ADDENDUM NO. 2

Date: March 21, 2024

Project: West Regional Library Renovation
Cary, NC

INTERIOR PARTITION TYPES

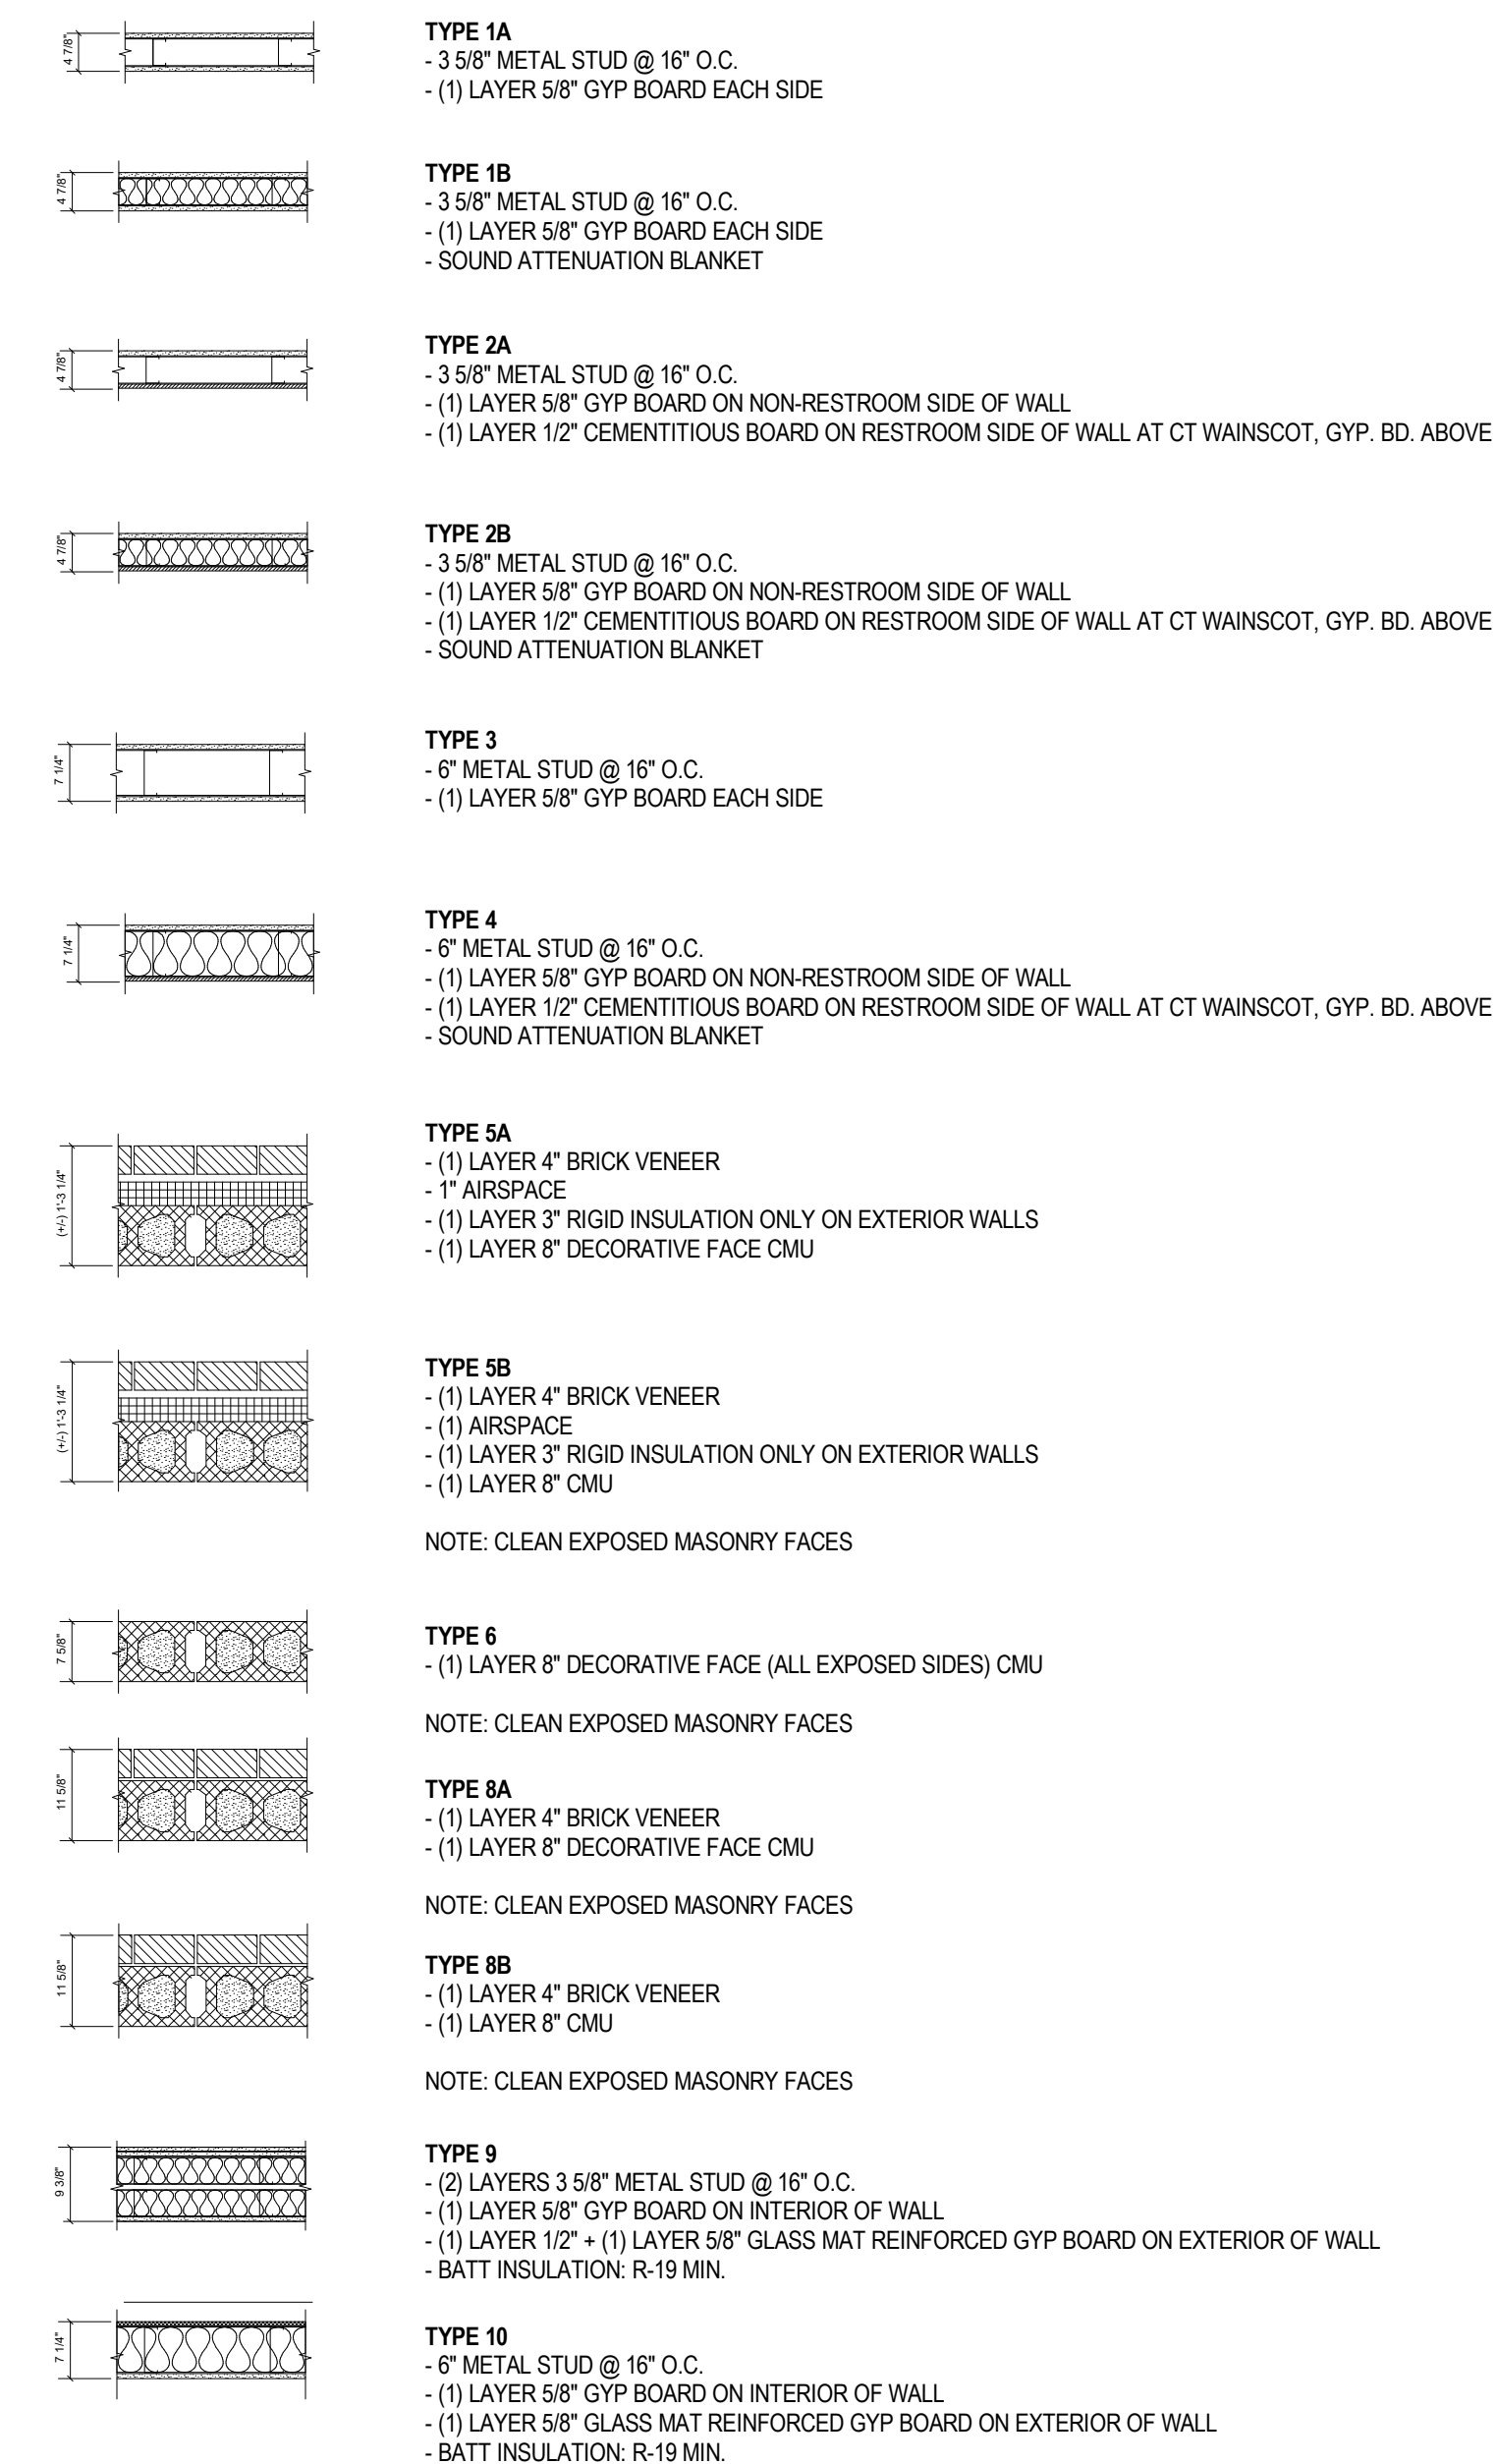
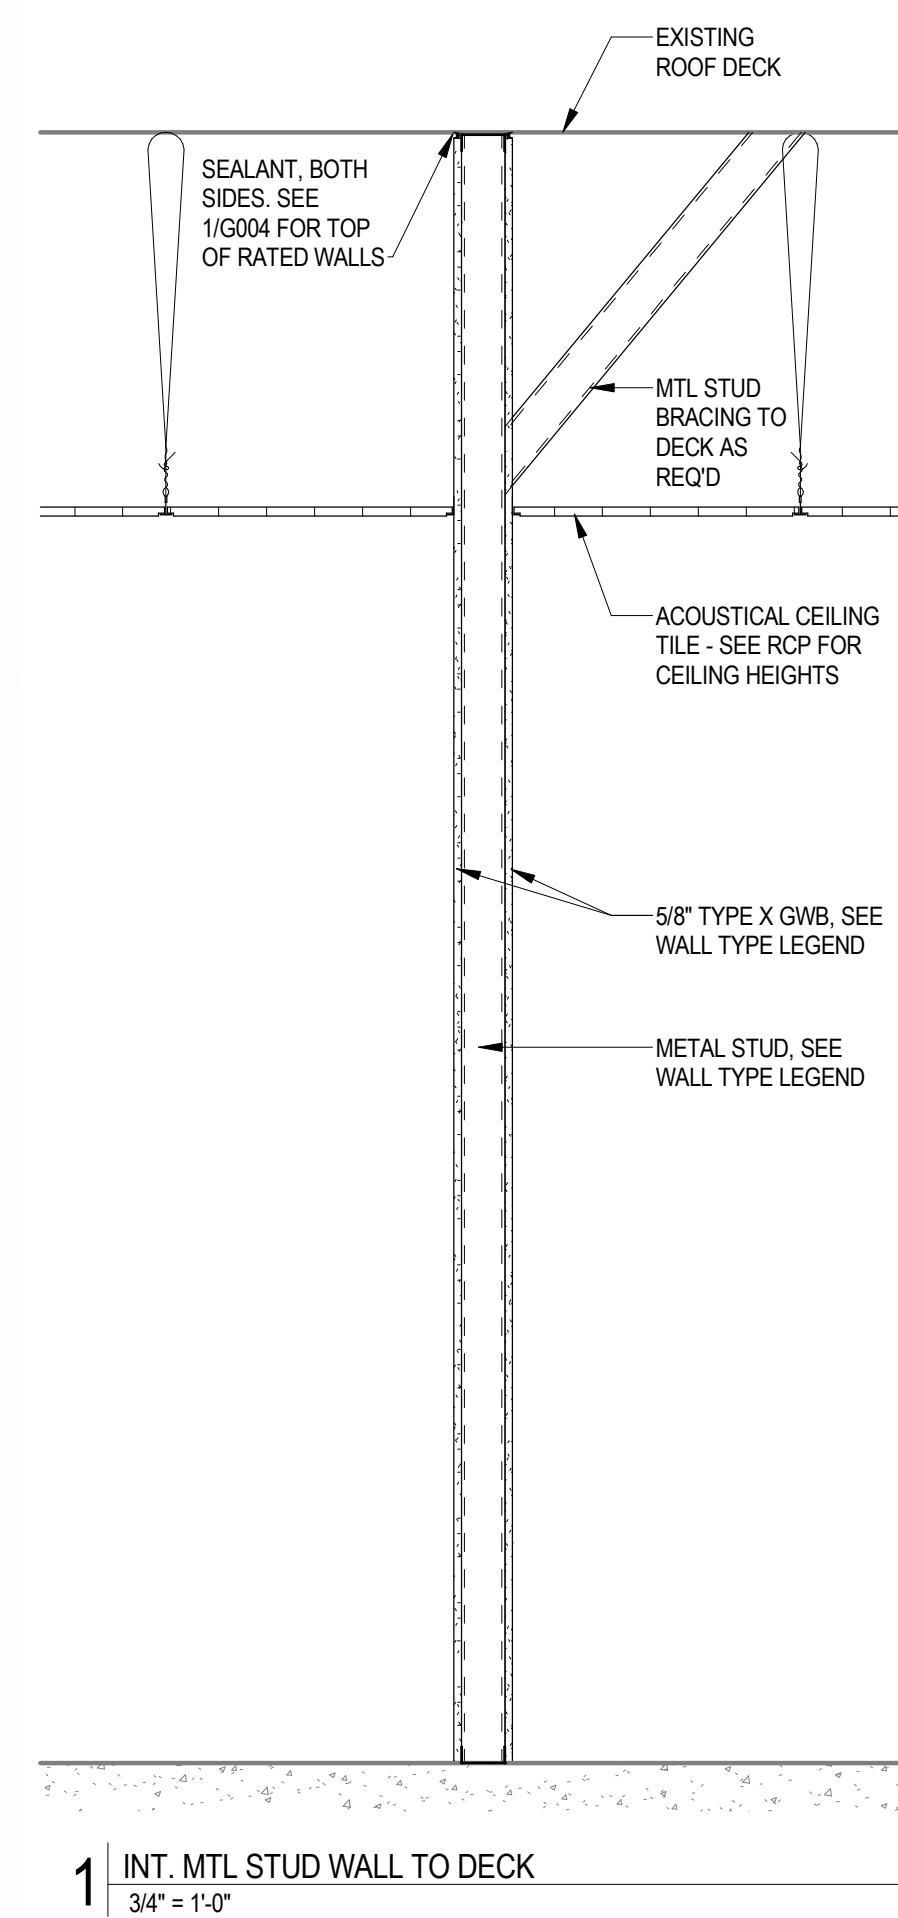
ITEM 13. Question: Are there elevations for 125A?

ITEM 23: Sheets A101 and G005 have been **revised** to clarify the extension of the existing chiller pad in preparation for the new chiller.

Response: **Refer to** Interior Partition Types on Sheet G005 for details and wall height for wall type 2.6R1.

SHEET NO.
A121

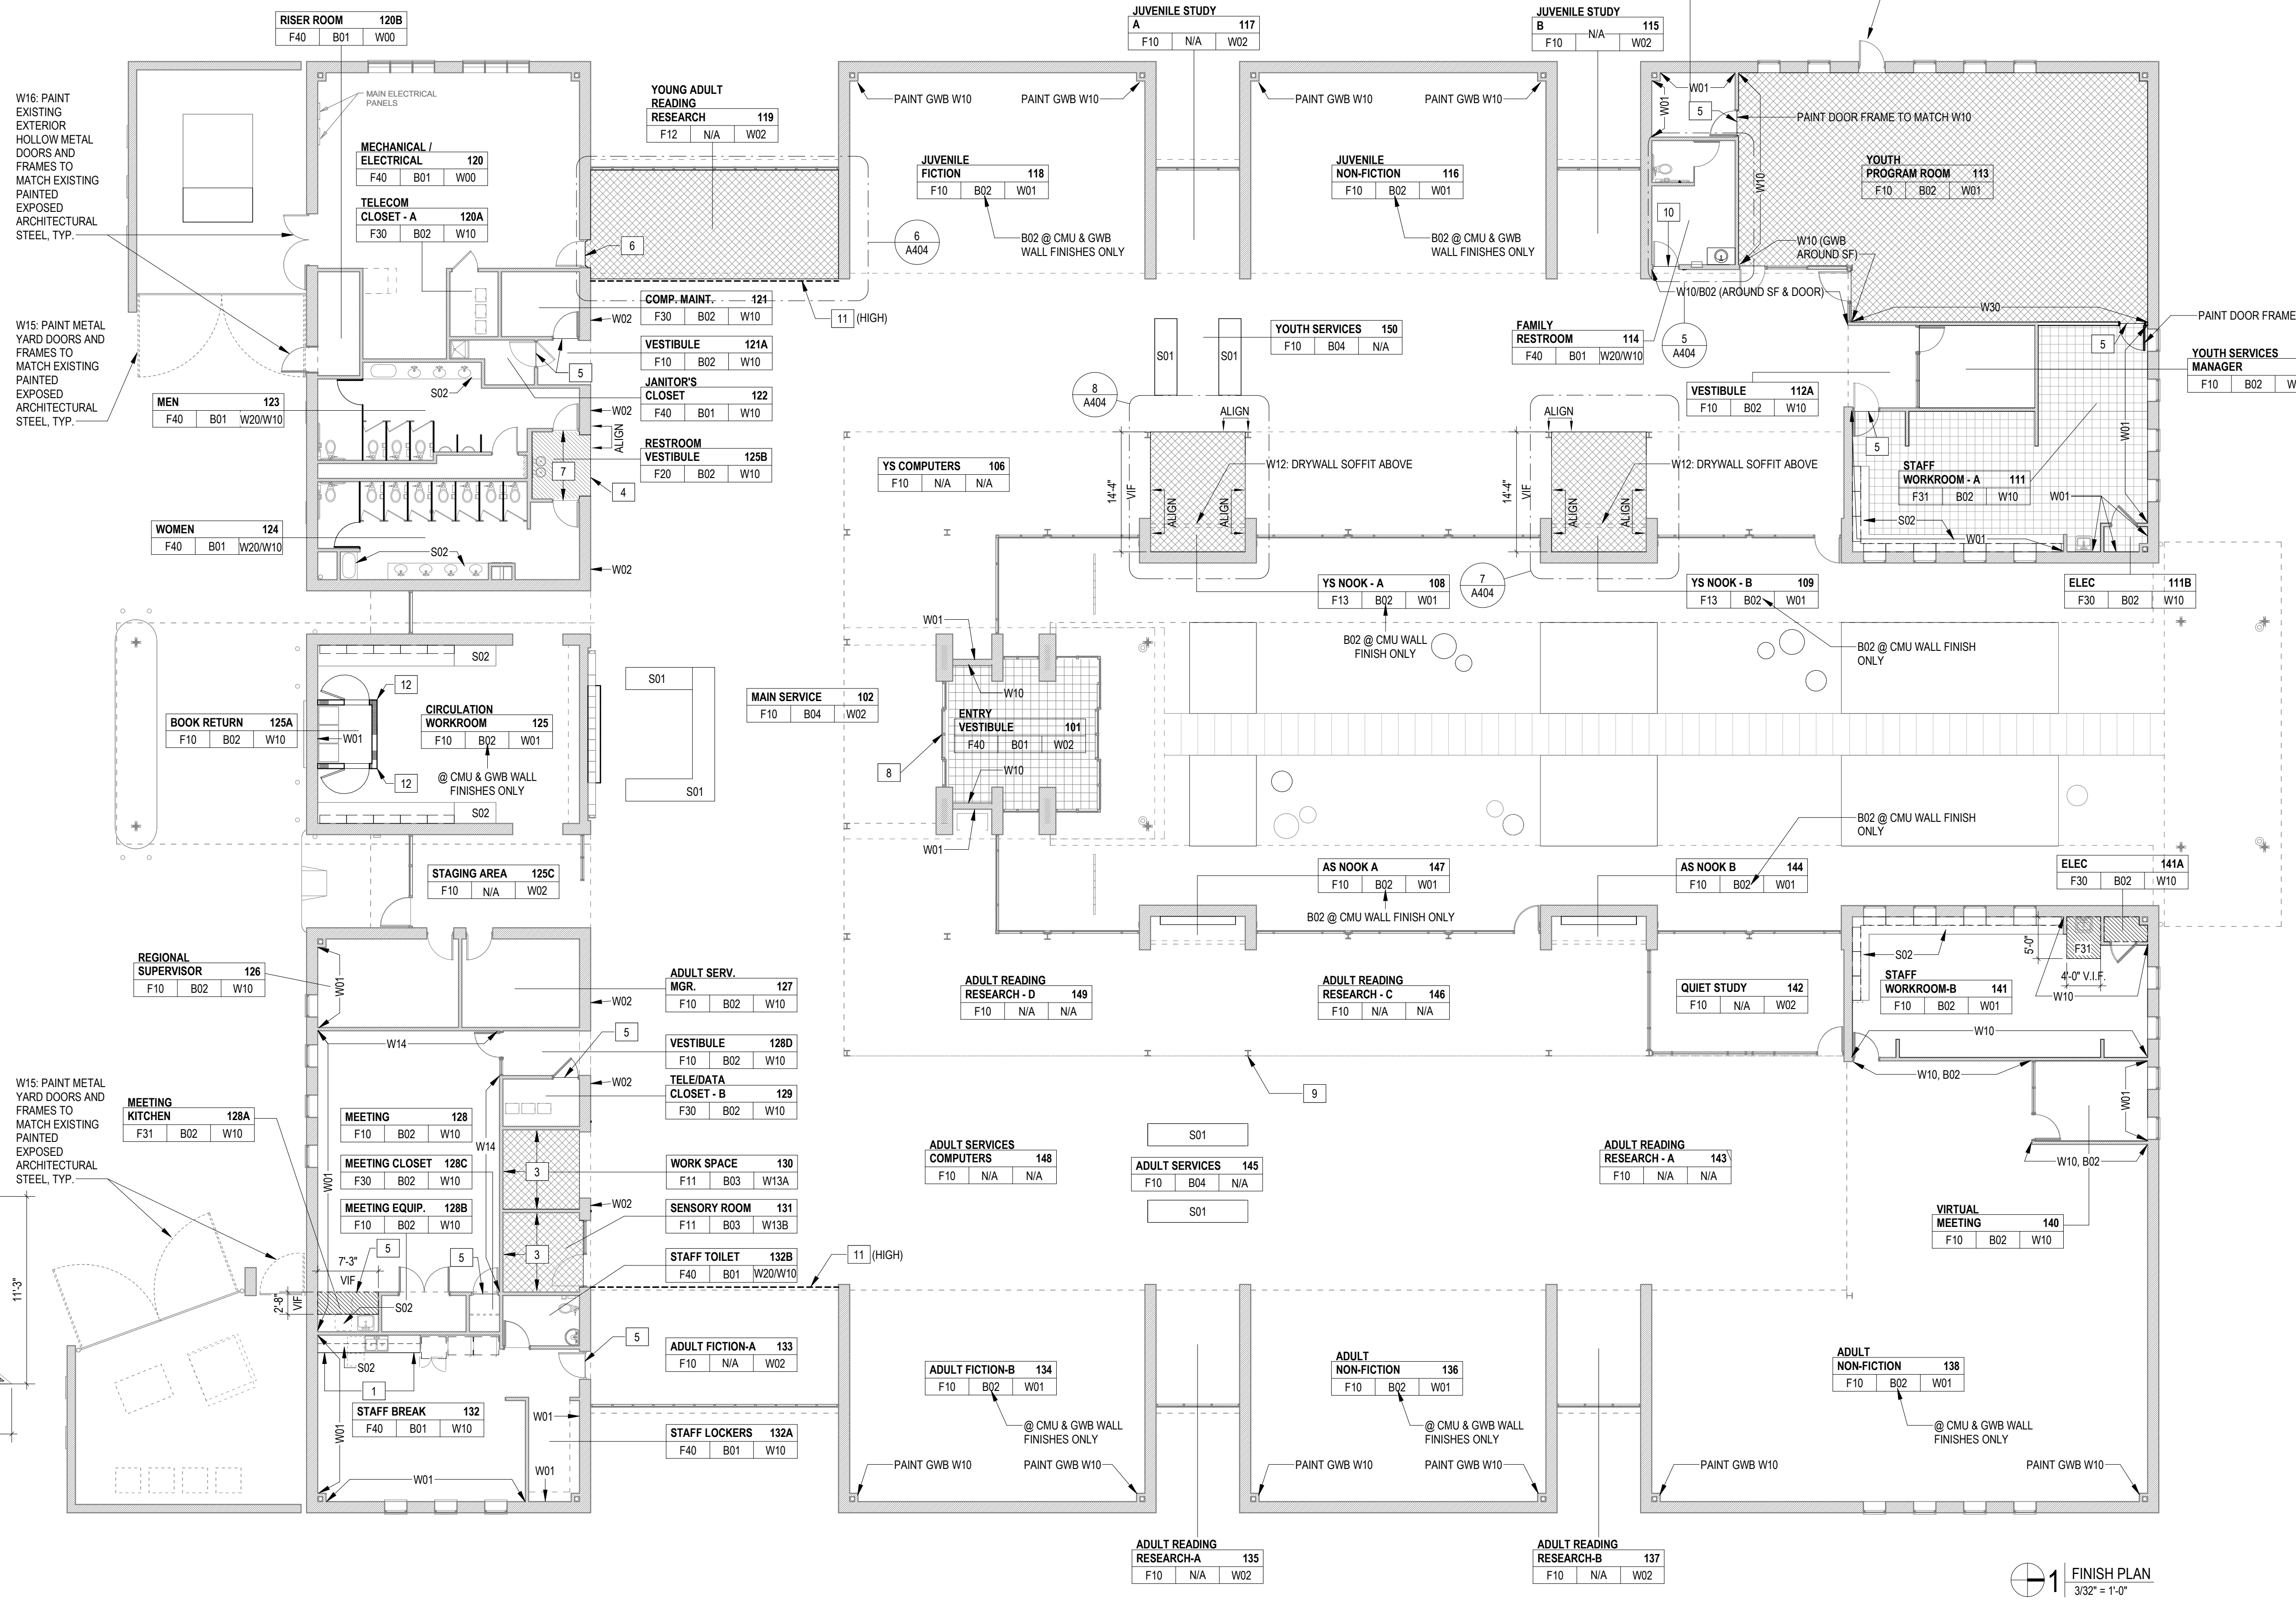
ITEM 24: Sheets A121 and A404 have been **revised** to reflect changes in carpet selection and layout at Young Adult Reading Research 119.
